# CITY OF ALBUQUERQUE

**Re: Chelwood Park Apartments Grading and Drainage Plan  
Engineer's Stamp date 01-16-12 (J22/D001)**

**RE: Grading and Drainage Plan  
Chelwood Park (J22/D001)**

**Re: Chelwood Park Apartments Grading and Drainage Plan**  
**Engineer's Stamp date 12-28-11 (J22/D001)**

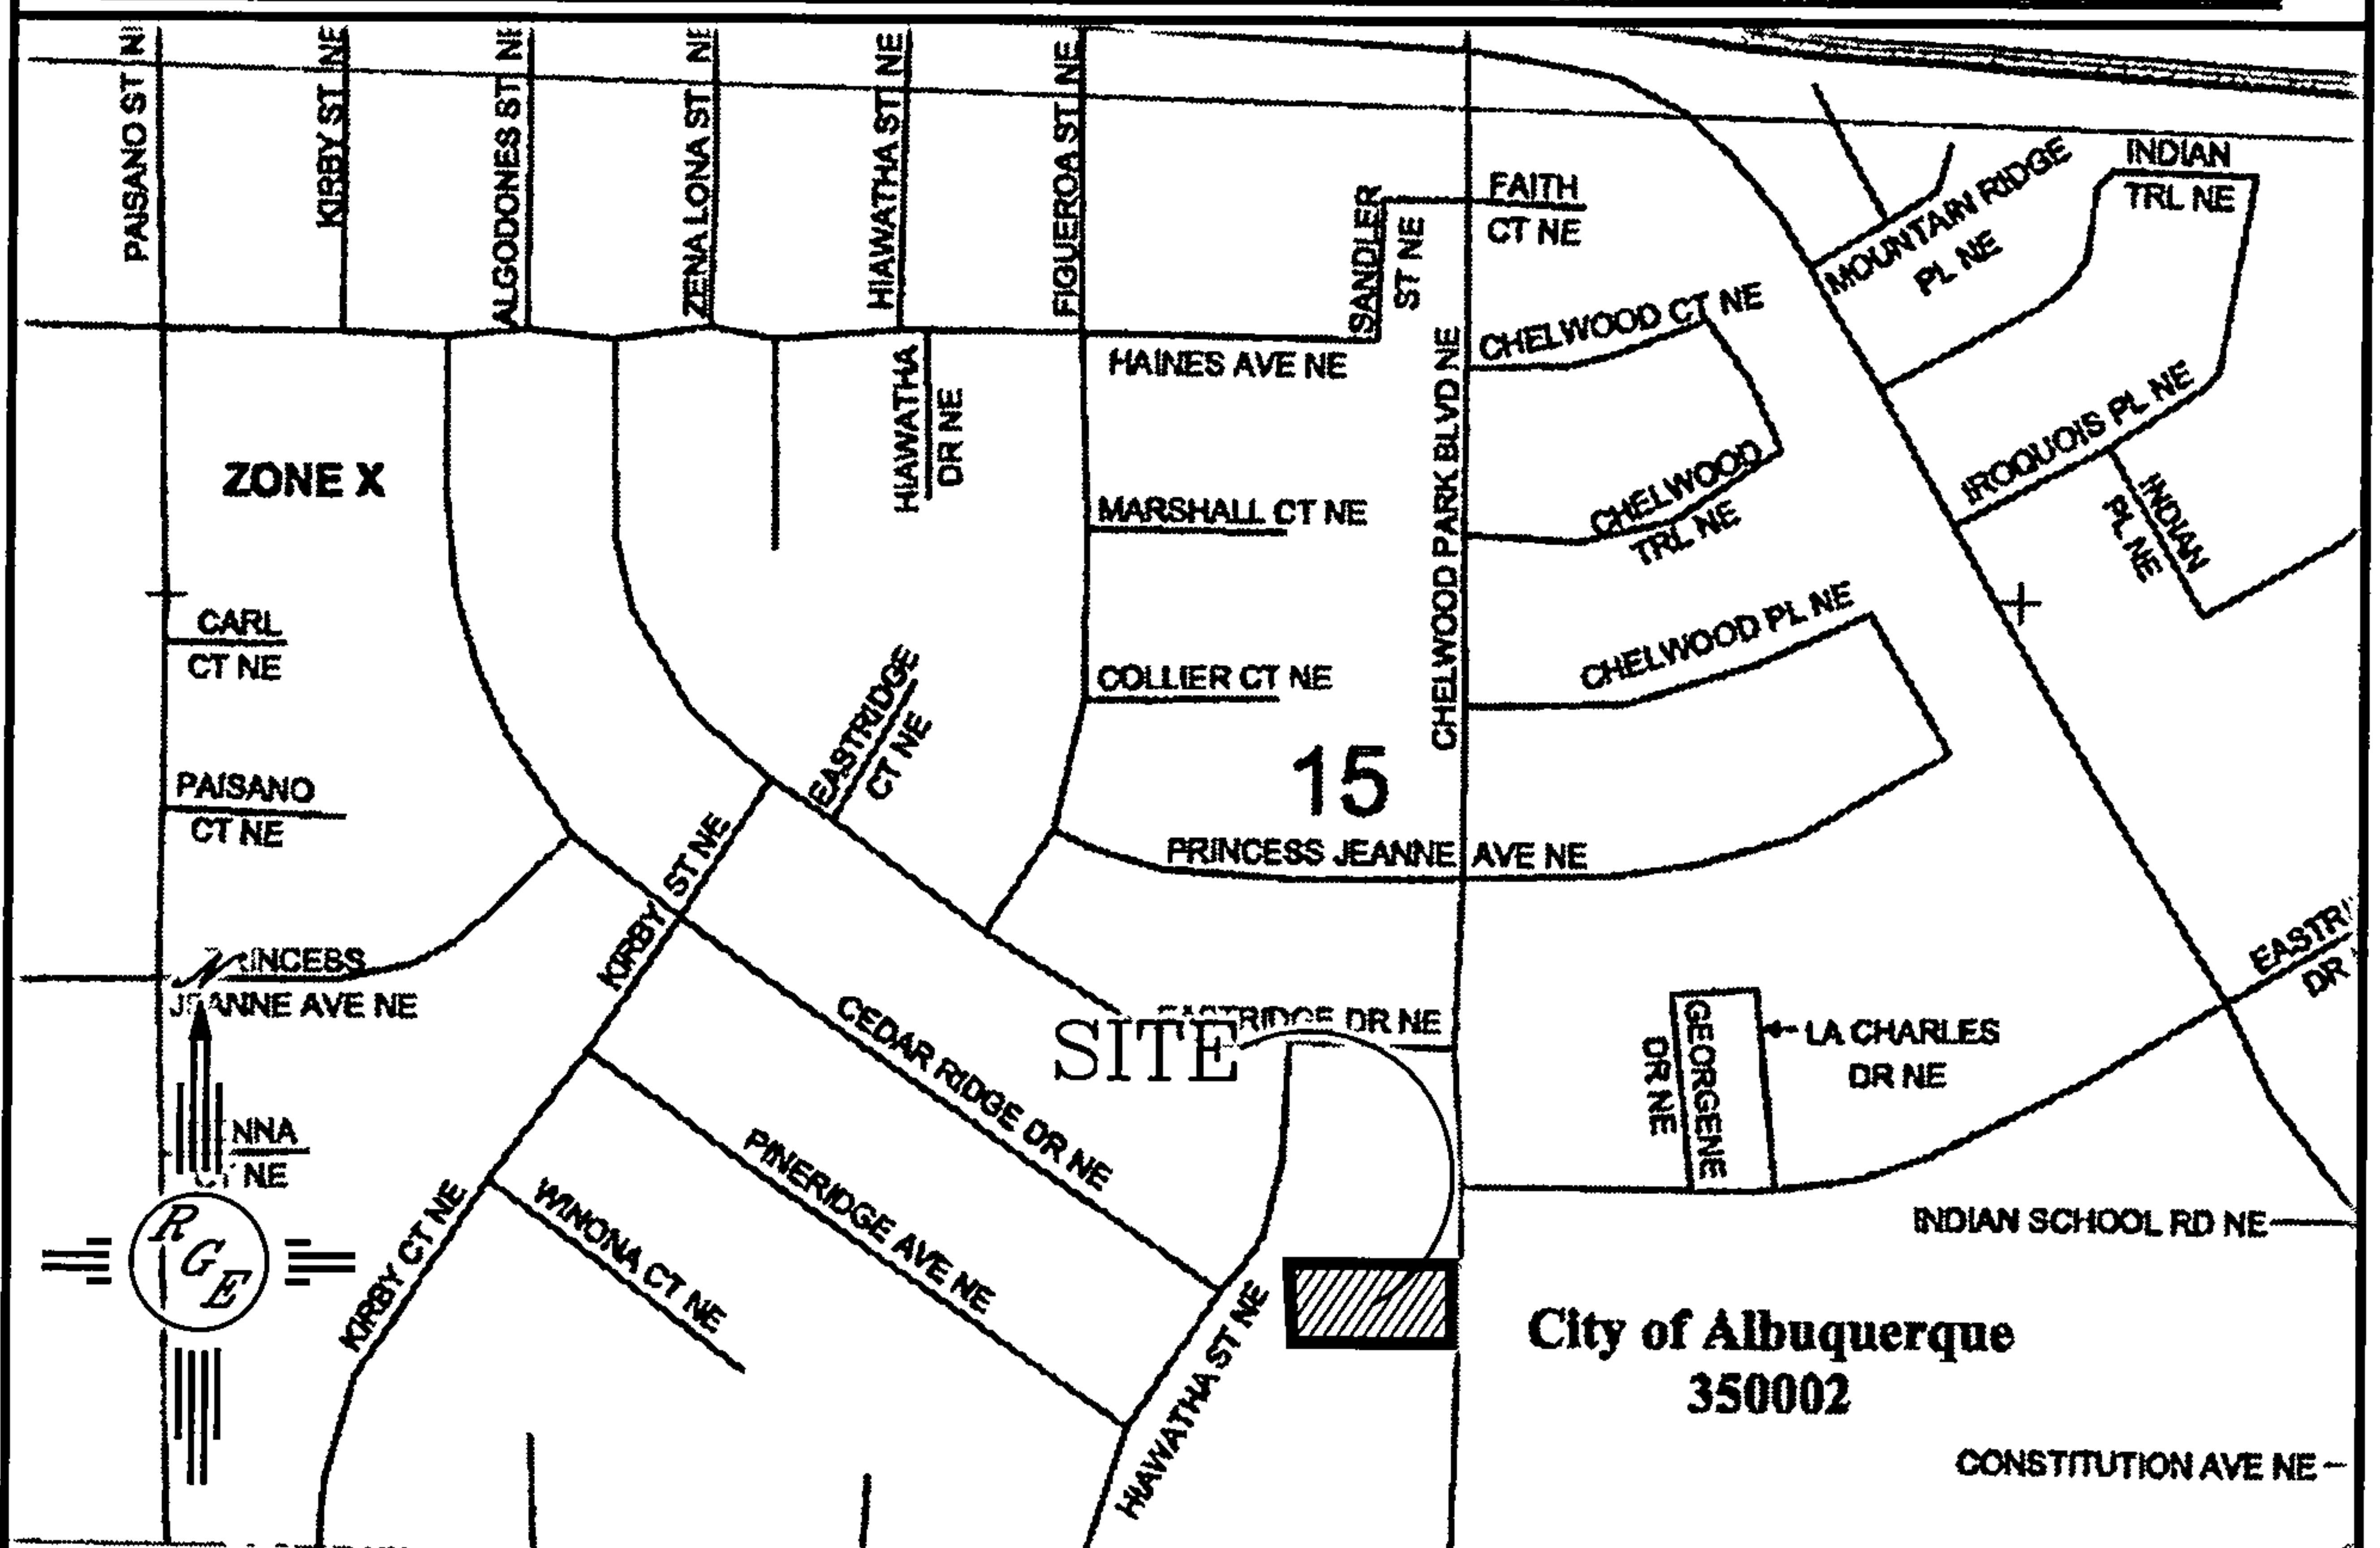
how is this accomplished?
